RISK REDUCTION FEASIBILITY STUDY
OF SELECTED MODIFICATIONS TO
CRBRP SAFETY SYSTEMS

FINAL REPORT

SAI-84-123-WA

U.S. Nuclear Regulatory Commission
Washington, D.C. 20555

Figure 3-2. FAULT TREE FOR THE FAILURE OF DHRs

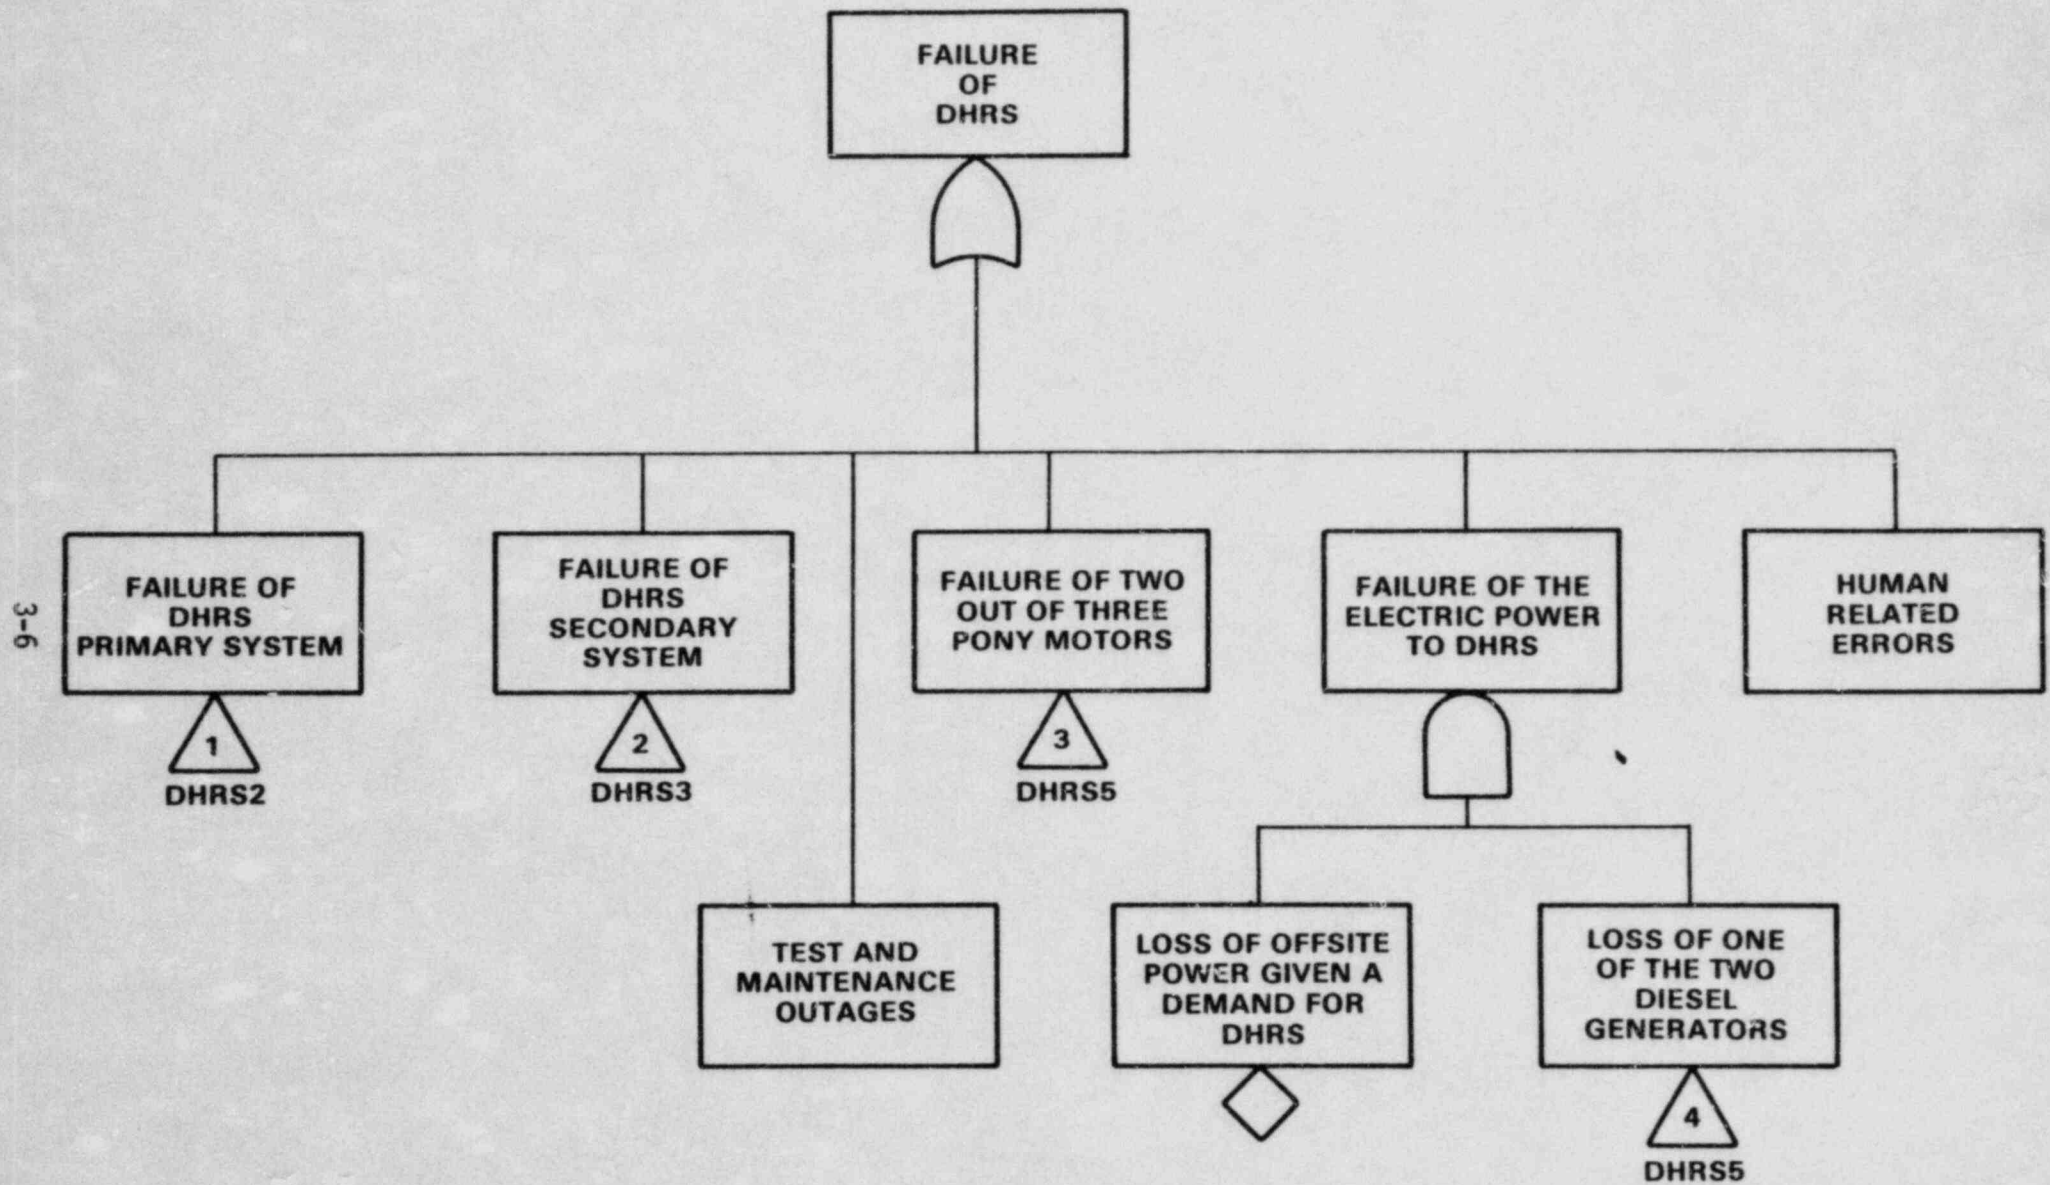
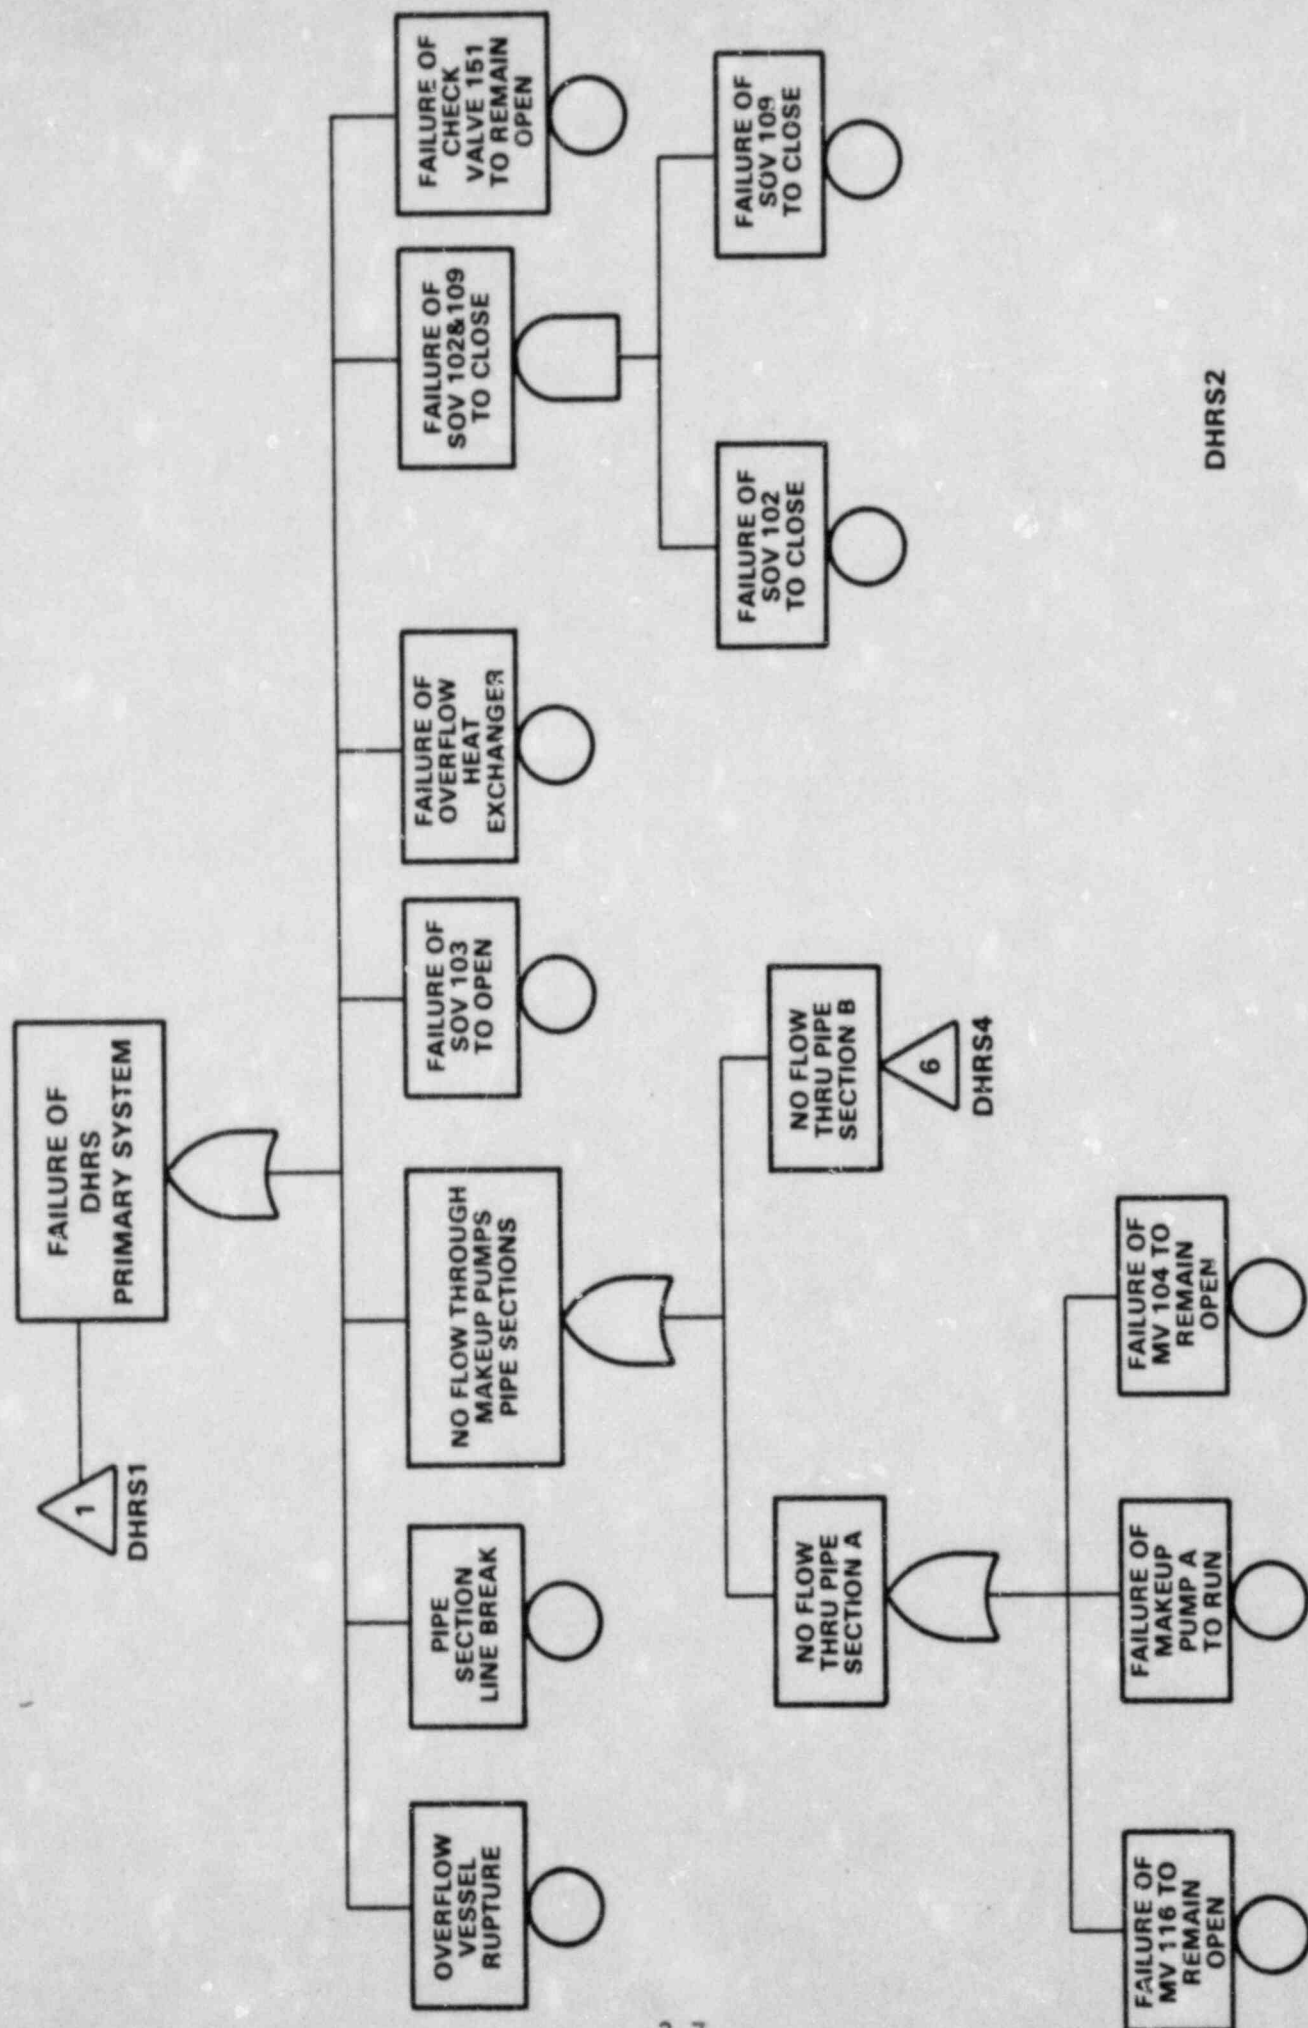
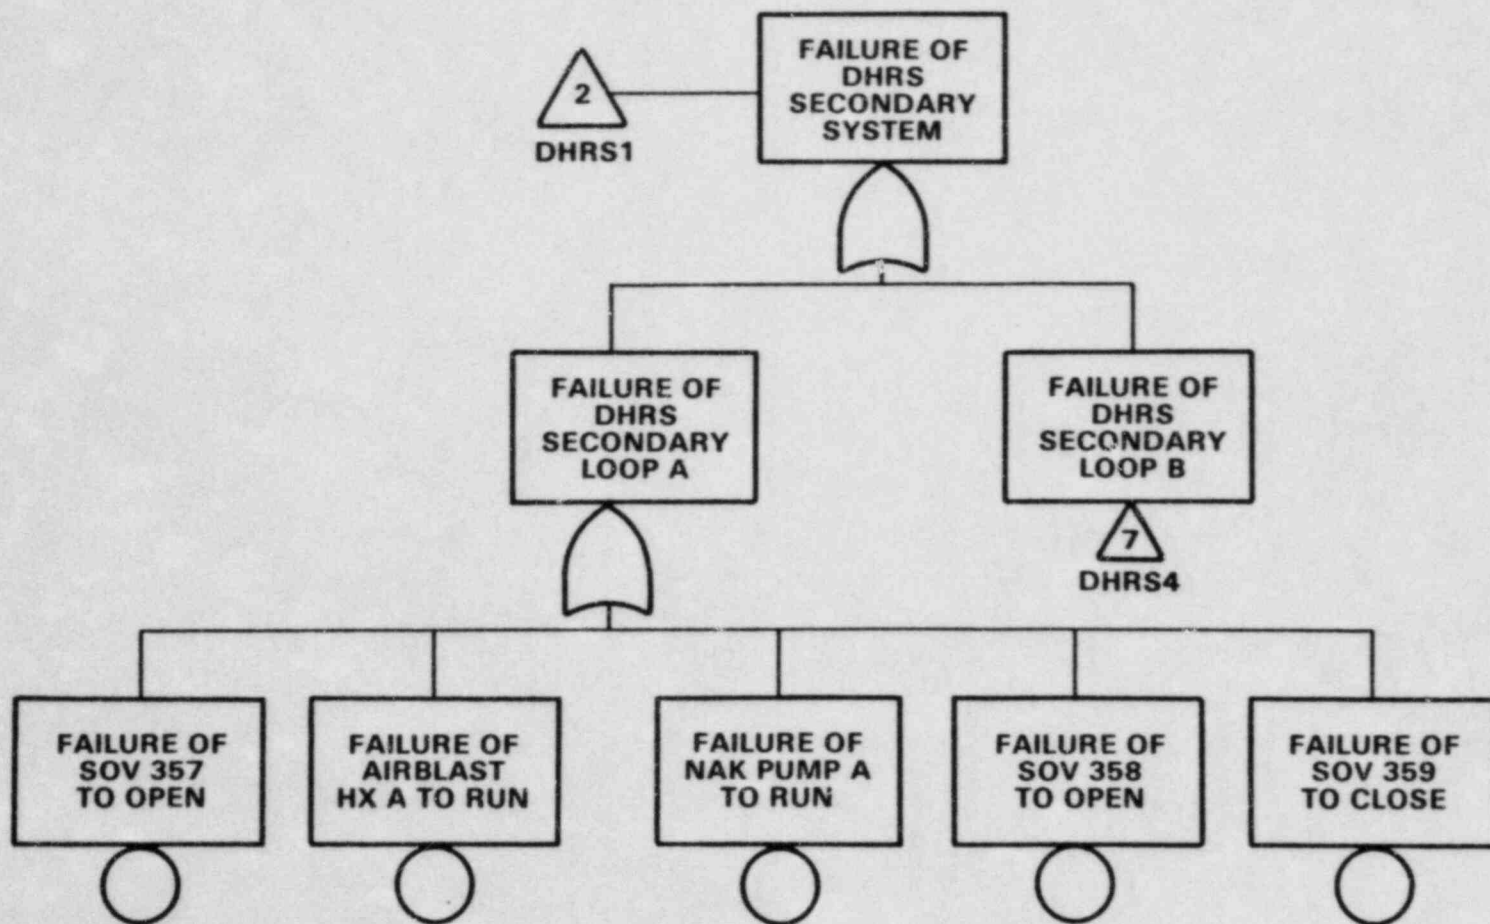
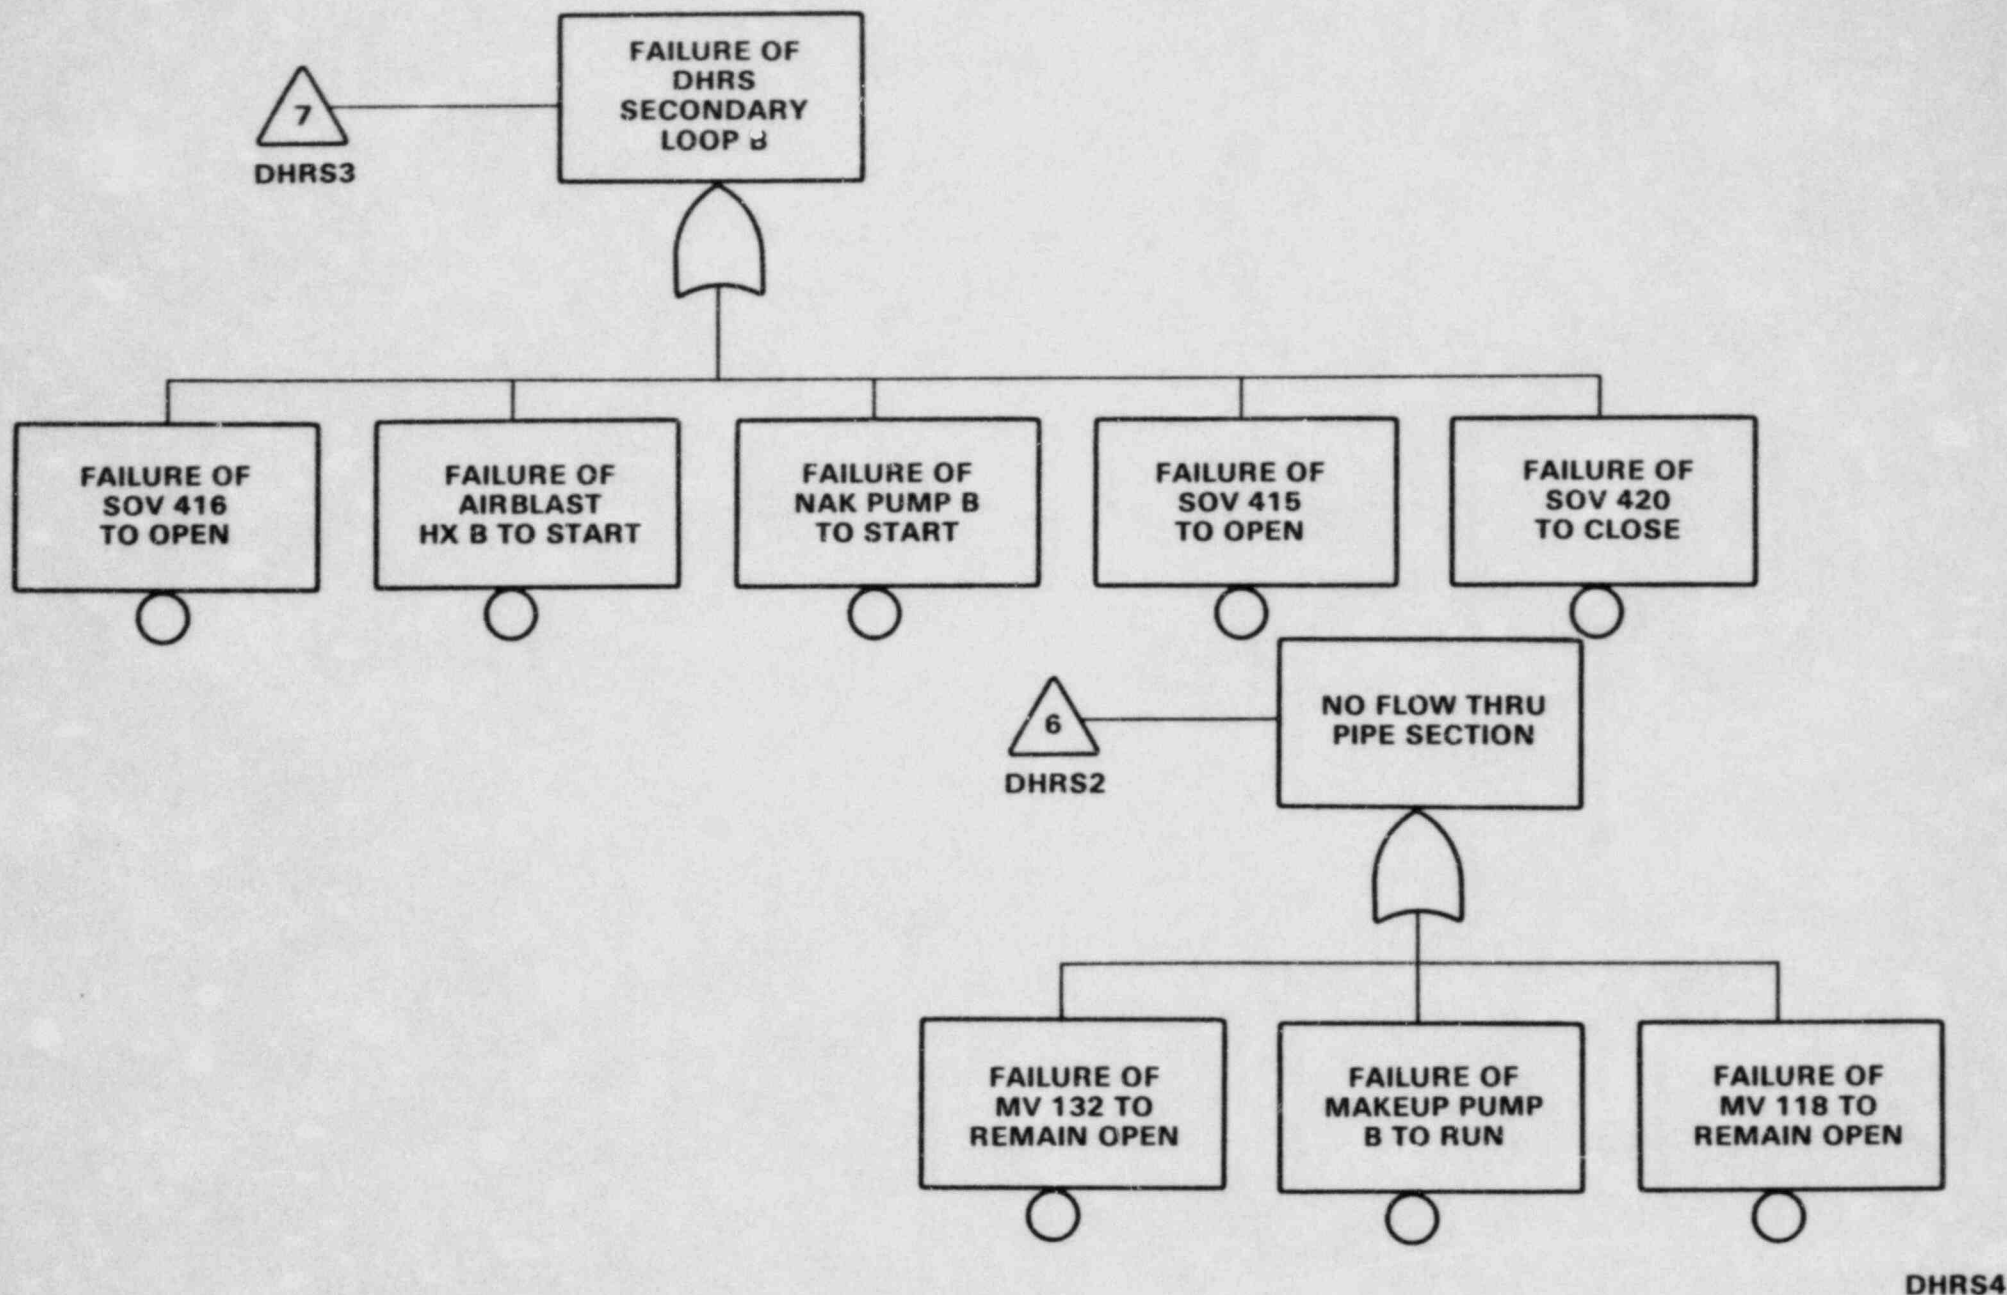
As can be seen from the table the failure probability of the DHRS is dominated by failure of any one of seven valves to change state and one NaK pump to start. This is because neither the primary system nor the secondary system is redundant initially, i.e., all the valves and the pump failures are single element minimal cut sets. As was mentioned earlier, after a period of operation of DHRS (approximately 30 hours) the decay heat is reduced to the point where only operation of one secondary loop is necessary. With respect to the question of possible need for a diverse source of AC power to the DHRS it is clear from the table that the contribution of failure of the electric power to the failure of the DHRS is very small. This is due to the fact that the DHRS is only required when all three primary heat transport loops are lost. Thus if the accident initiator is the loss of all three main heat transport loops where DHRS has to remove the decay heat, for the system to be disabled there must be a loss of

Event	Failure Probability	Major Contribution
Failure of DHRS Primary System	1.0×10^{-3}	Failure of SOV 103 to Change State
Failure of DHRS Secondary System	7.0×10^{-3}	Failure of Six SOV's and one NaK Pump to Start
Failure of Two Out of Three Pony Motors	3.0×10^{-8}	
Failure of Electric Power to DHRS	1.6×10^{-5}	
Human Related Error	1.0×10^{-4}	Only Operator Error to Initiate the System is Assumed
DHRS Failure on Demand	8.1×10^{-3}	Failure of Seven SOV's to Change State and One Pump to Start
